DEVELOPMENT APPLICATION ASSESSMENT REPORT

Application Number:	DA2024/0009
----------------------------	-------------

Responsible Officer:	Nick Keeler
Land to be developed (Address):	Lot 1 SP 74337, 1 / 6 Jackson Street BALGOWLAH NSW 2093
Proposed Development:	Alterations and additions to a Residential Flat Building
Zoning:	Manly LEP2013 - Land zoned R1 General Residential
Development Permissible:	Yes
Existing Use Rights:	No
Consent Authority:	Northern Beaches Council
Land and Environment Court Action:	No
Owner:	Susan Lorraine Mann
Applicant:	Richard Clive Mann

4.6 Exceptions to development standards

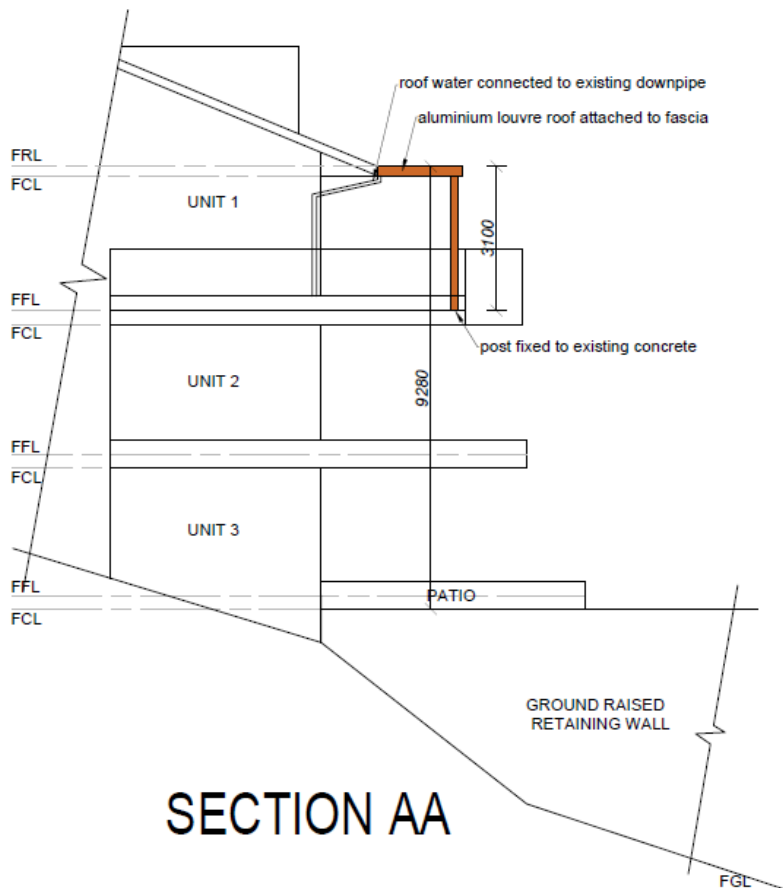
The application seeks consent to vary a development standard as follows:

Development standard: Clause 4.3 Height of Buildings

Requirement: 8.5m

Proposed: 9.28m

Percentage of variation: 9.2%

- *The development will be attached to an existing building, which already exceeds the maximum height because it is built on a slope.*
- *The development will be located below the lowest edge of the roof of the existing building and will result in no addition to the overall height of the existing building.*
- *The maximum height of the development itself down to vertical ground level exceeds the development standard by only a small amount.*
- *It is not possible to attach the pergola roof to the existing building at a lower level.*

Council is satisfied that the Applicant has demonstrated that there are sufficient environmental planning grounds to justify the contravention of Clause 4.3 Height of buildings for the following

- The proposed development represents a technical non-compliance that will not alter the overall height of the existing building.
- The proposed development will not cause any unreasonable built form or amenity impact upon adjacent properties.

- The building height does not cause unreasonable view loss.
- The proposed development generally maintains the pattern of the neighbourhood including predominant heights.

It is considered on balance, that having regard to the particular circumstances of the proposed development being a small-scale ancillary structure attached to the existing building, the proposed departure from the development standard is acceptable and it is reasonable that flexibility to the standard be applied.
